SERVICE BULLETIN

SUBARU CORPORATION

Subject:	Part Change Information: New Part for GASKET-SPARK PLUG PIPE with higher durability
Applicable Section in Service Manual:	Engine > IGNITION > Spark Plug
Applicable Parts name in Parts System:	Engine > CYLINDER HEAD > GASKET-SPARK PLUG PIPE
Foreword:	This Service Bulletin is to inform you of the new part GASKET-SPARK PLUG PIPE with higher durability as countermeasure part against the problem that oil seepage comes from GASKET-SPARK PLUG PIPE.

Location of the affected parts

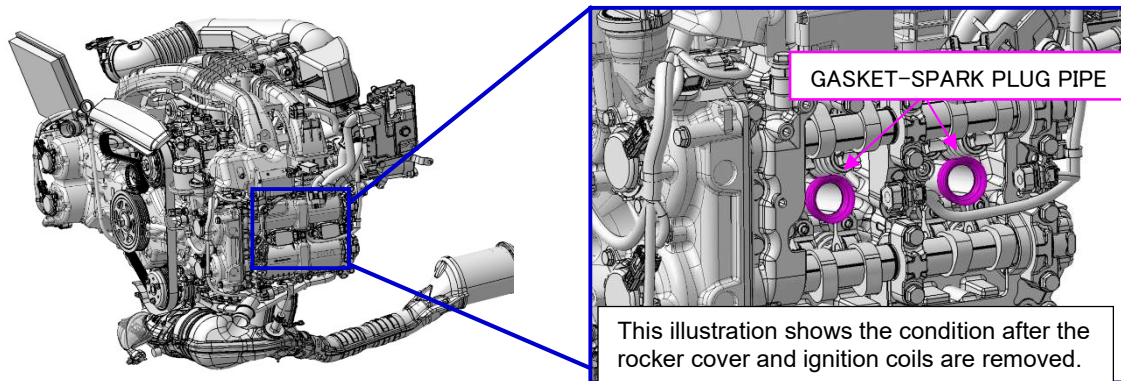
Symptom	Details of Symptom and Improvement
Oil seepage from GASKET-SPARK PLUG PIPE can be seen.	<p>Details of Symptom, Cause: When the engine is kept operated under the severe condition, the rubber material of GASKET-SPARK PLUG PIPE deteriorates and becomes hard, resulting in oil seepage through GASKET-SPARK PLUG PIPE.</p> <p>Details of Improvement: Changed the rubber material of GASKET-SPARK PLUG PIPE to higher durability one.</p> <p>If the problem is reported, replace GASKET-SPARK PLUG PIPE with the new one.</p> <p>Note: 1. GASKET-SPARK PLUG PIPE is not a reusable part. Do not reuse the old GASKET-SPARK PLUG PIPE. 2. The shape, color, and size of new/old parts are identical.</p>

No.	New Parts		Interchangeability	Old Parts	Note
1	Part No.	10966AA042	New Part to Old Vehicle: Yes. Old Part to New Vehicle: No.	10966AA041	For all FA/FB engine models
	Part Name	GASKET-SPARK PLUG PIPE		GASKET-SPARK PLUG PIPE
